**Technical Service Bulletin (TSB)**  
**Diesel Exhaust Fluid (DEF) Fluid Freezing**

| <b>REFERENCE:</b>         | <b>TSB:</b> 25-007-24<br><b>GROUP:</b> 25 - Emissions Control  | <b>Date:</b>                           | October 1, 2024 | <b>REVISION:</b>             | 14-005-24 |
| <b>VEHICLES AFFECTED:</b> | <p>2019 - 2022 (DJ) RAM 2500 Pickup<br/>                 2019 - 2022 (D2) RAM 3500 Pickup<br/>                 2019 - 2022 (DD) RAM 3500 Cab Chassis<br/>                 2019 - 2022 (DP) RAM 4500/5500 Cab Chassis<br/>                 This bulletin applies to vehicles equipped with the 6.7L I6 Cummins Turbo Diesel engine (Sales Codes ETL and ETN) or a 6.7L I6 Cummins HO Turbo Diesel engine (Sales Code ETM).</p>  | <b>MARKET APPLICABILITY:</b>           |                 |                              |           |

**Fig. 1**  
DEF Tank Assembly

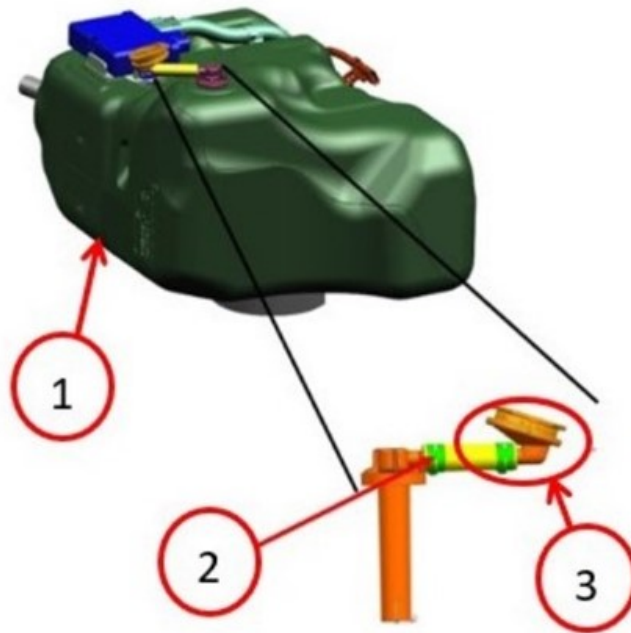
1. Loosen the hose clamp on the Grade Vent Valve (GVV) hose and replace the GVV from the DEF tank [Fig. 1](#).
